PLAN AND PROFILE OF PROPOSED STATE HIGHWAY

PRINCE WILLIAM PARKWAY INTERCHANGE AT REALIGNED BALLS FORD ROAD

VDOT Proj.No.6234-076-266

Notice of Design Change (NDC) #02
JUNE 2021

PL44-BMP-10 PROFILE VIEW
 RETENTION II FACILITY

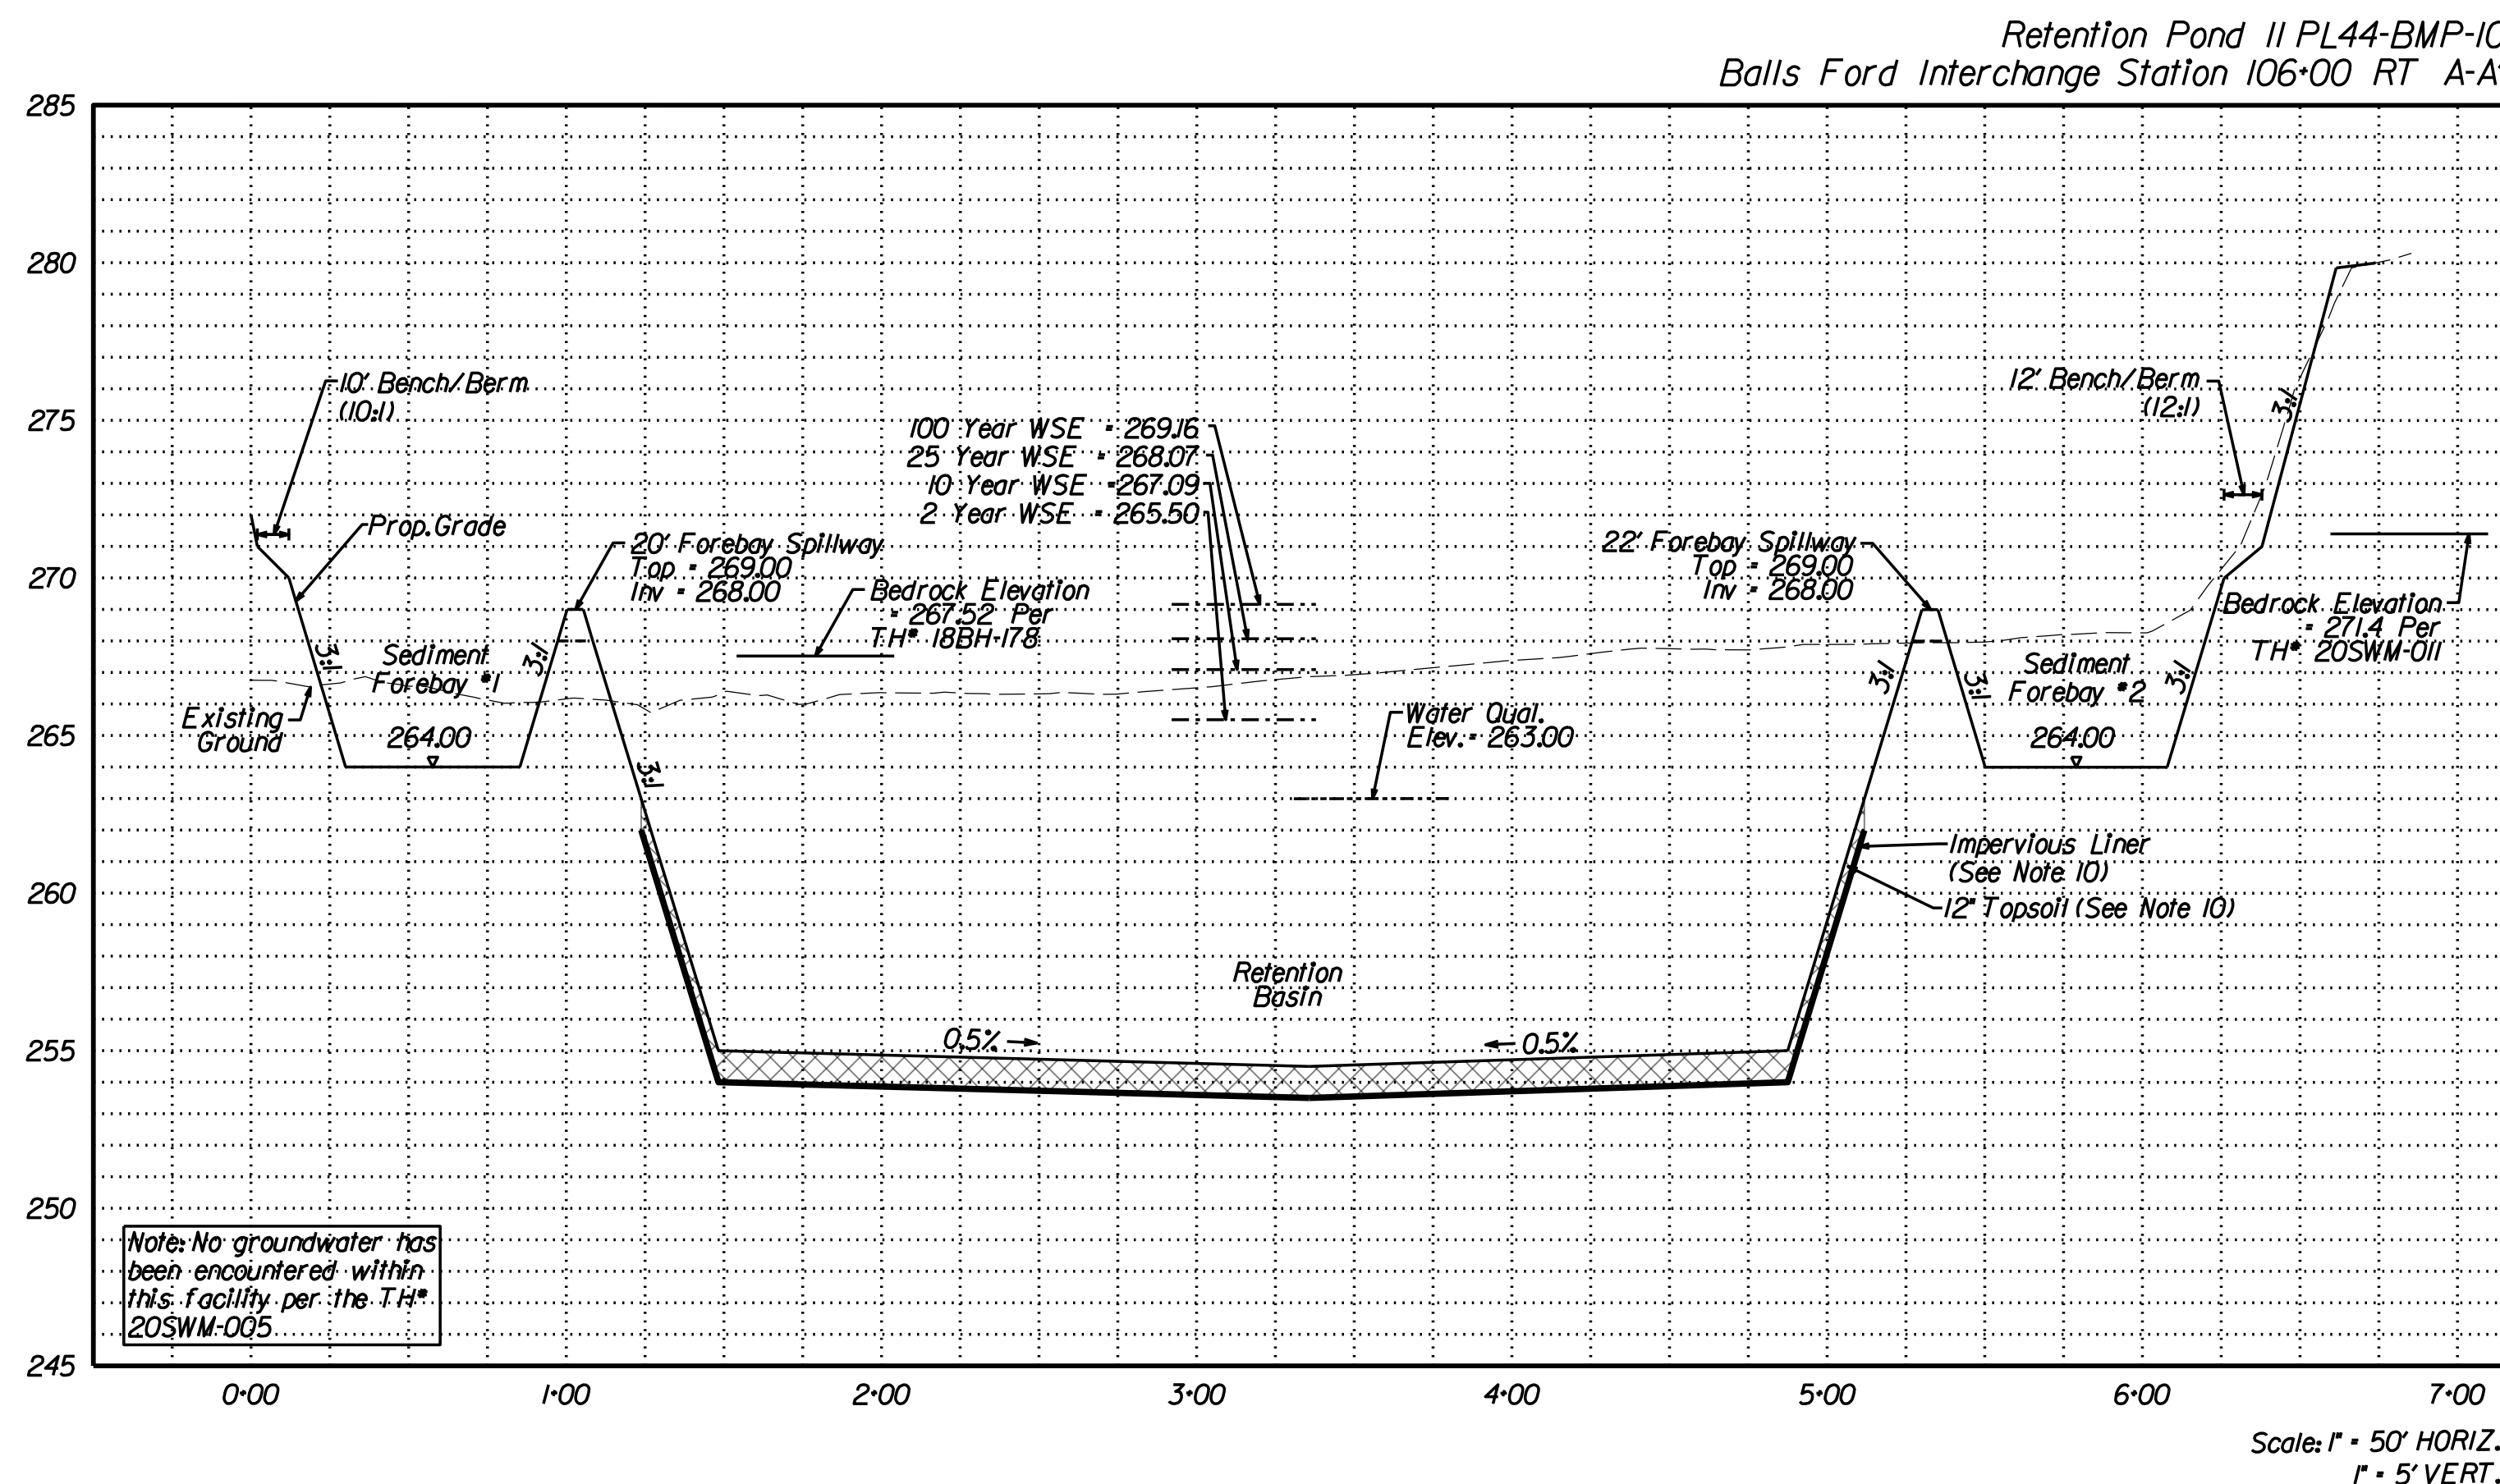
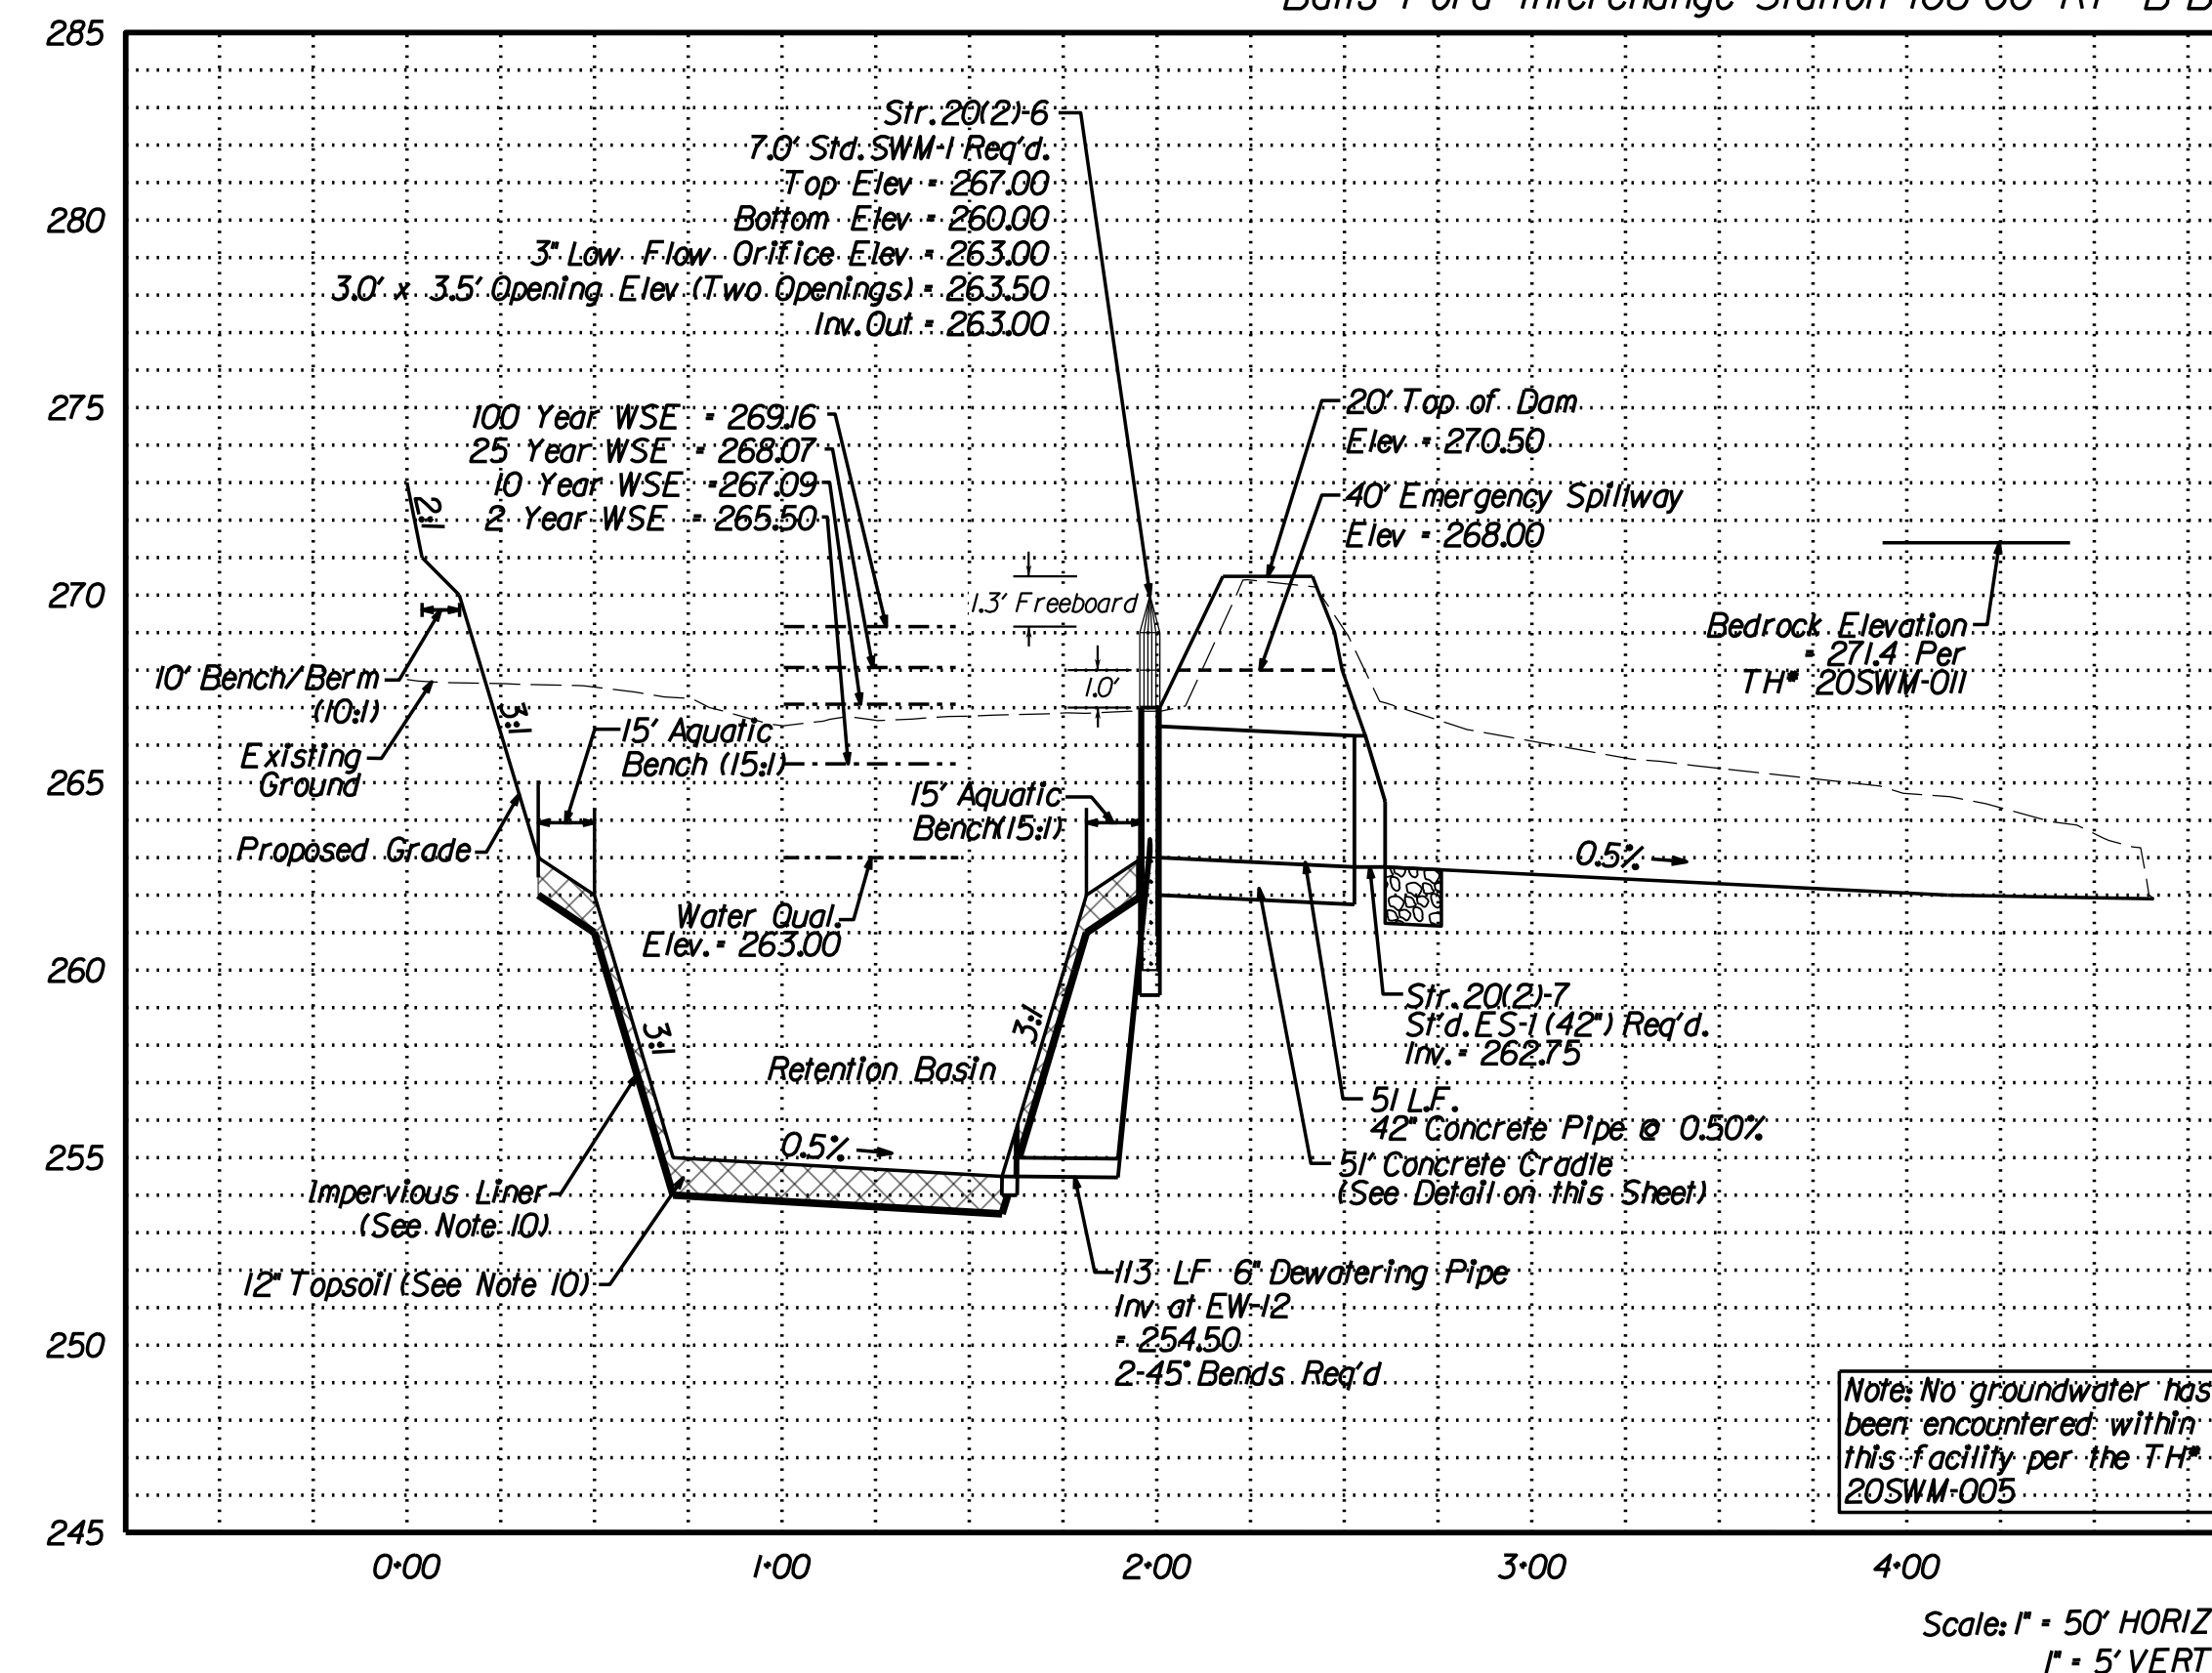
02 Revised profiles to show new WSEL.

FRONT VIEW
 (DEBRIS RACK NOT SHOWN)

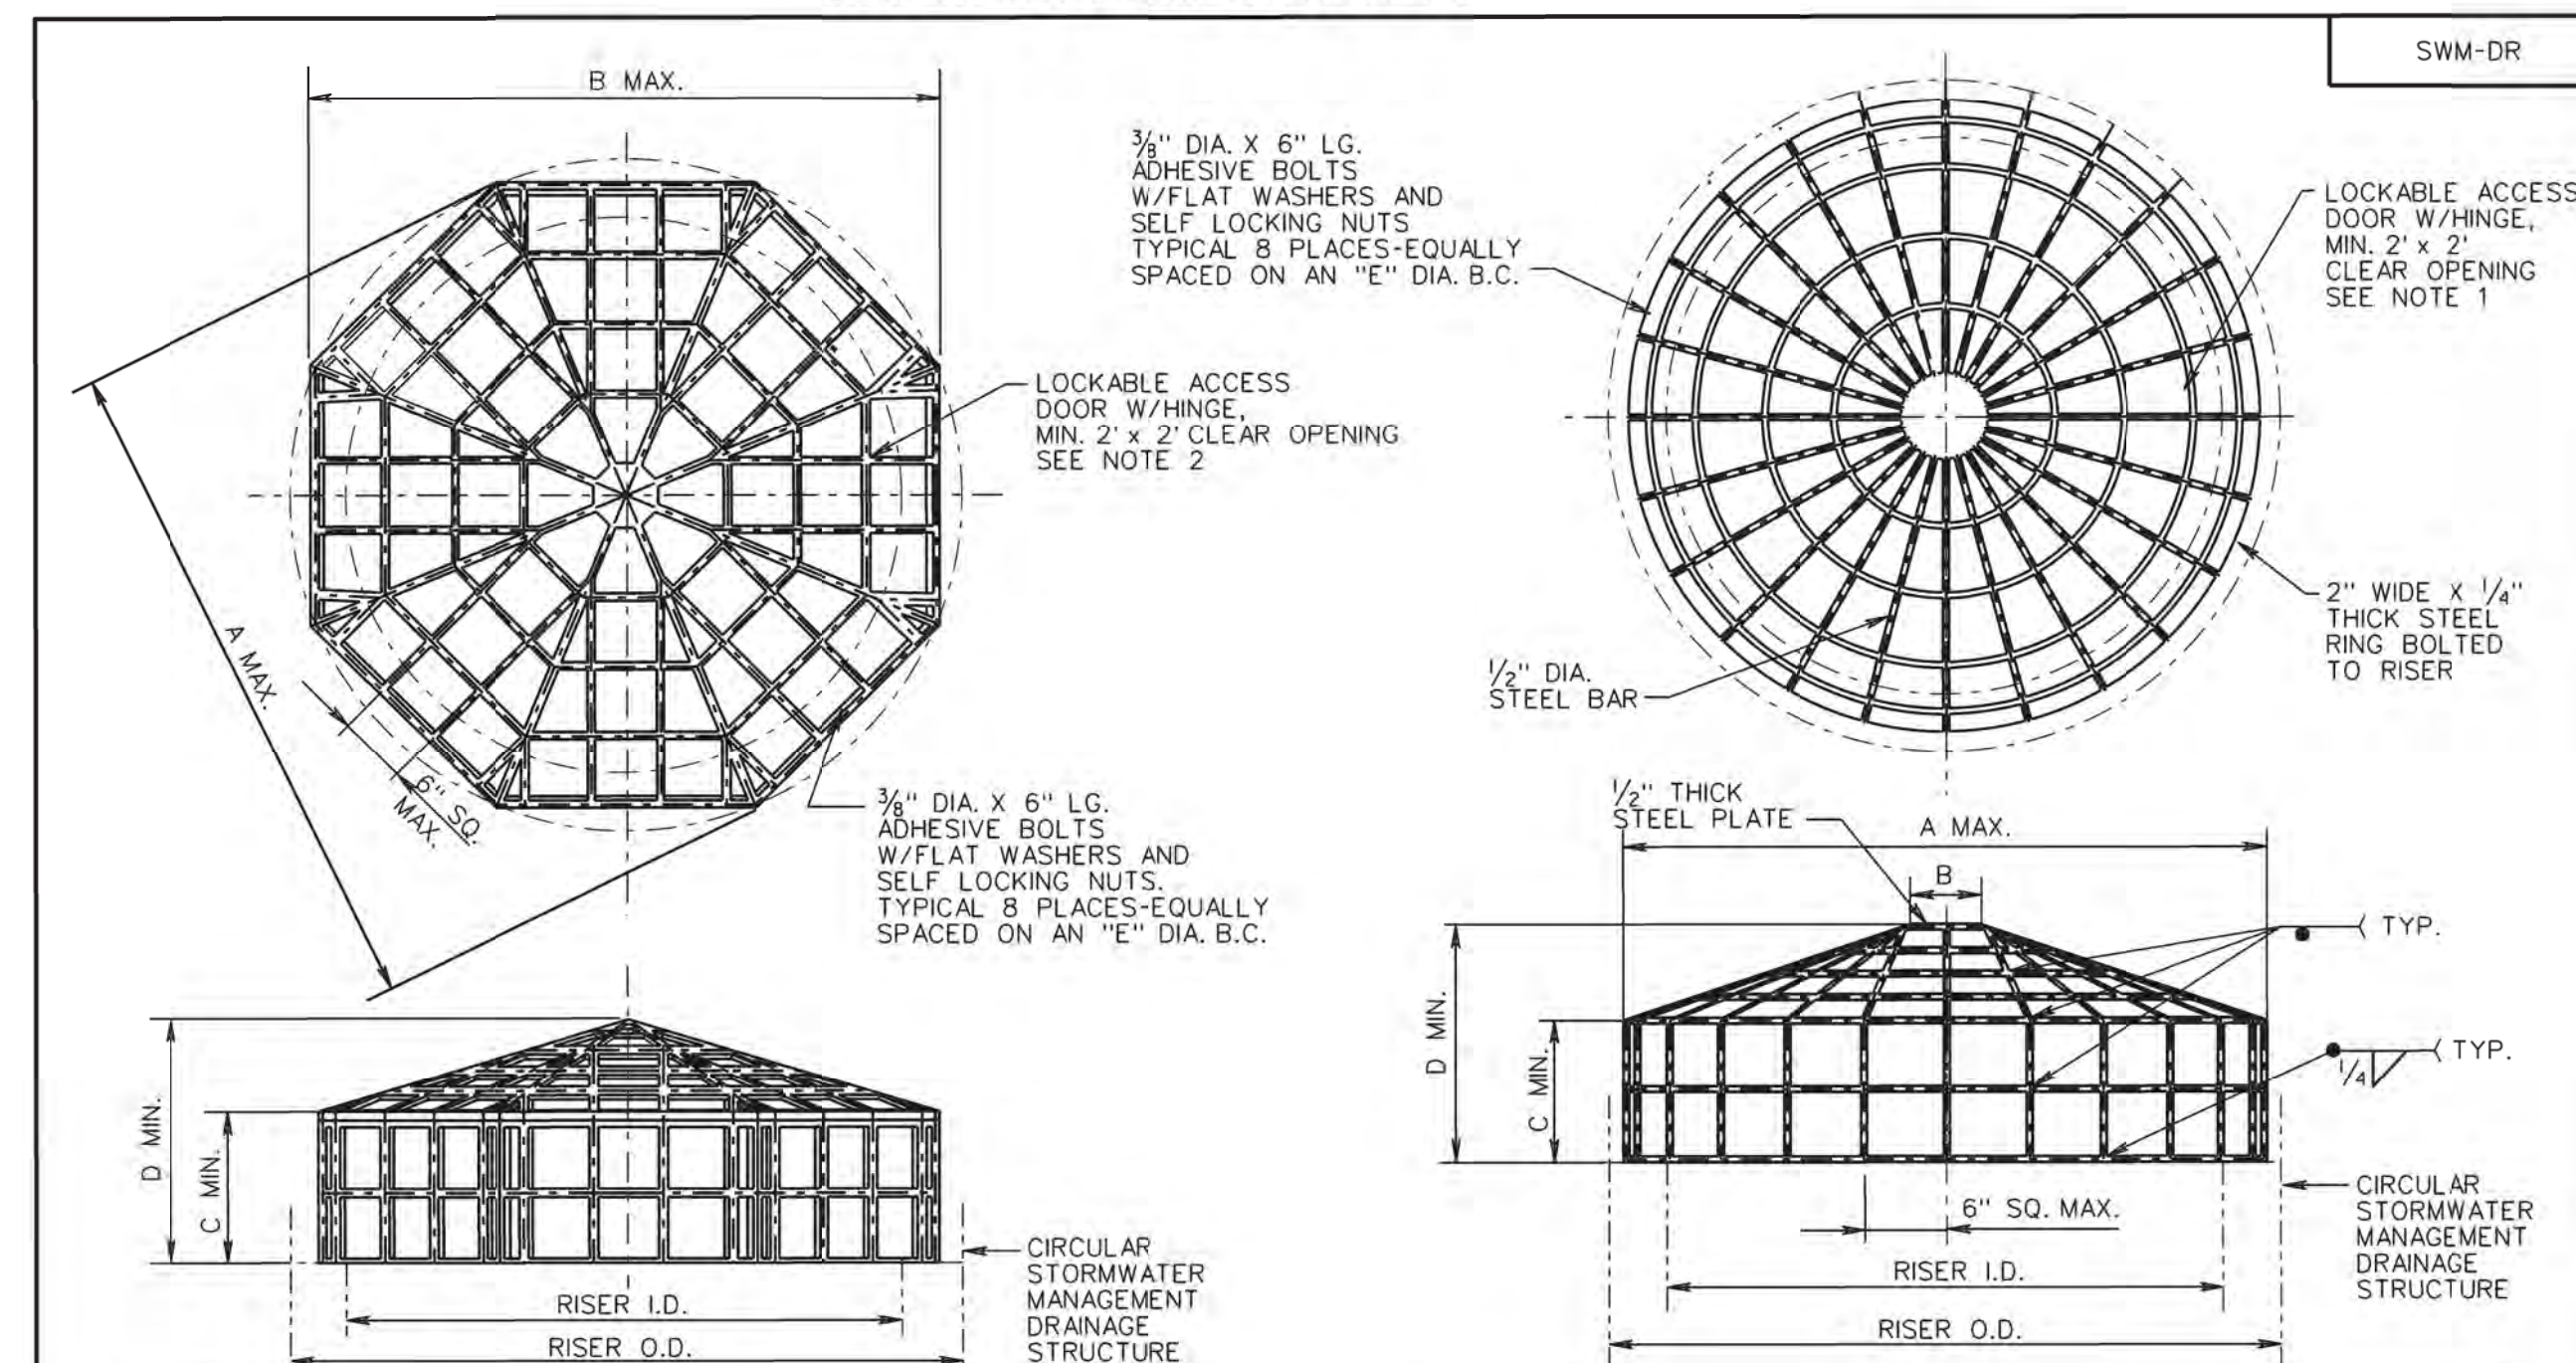
02 Revised riser detail to 72" ID.
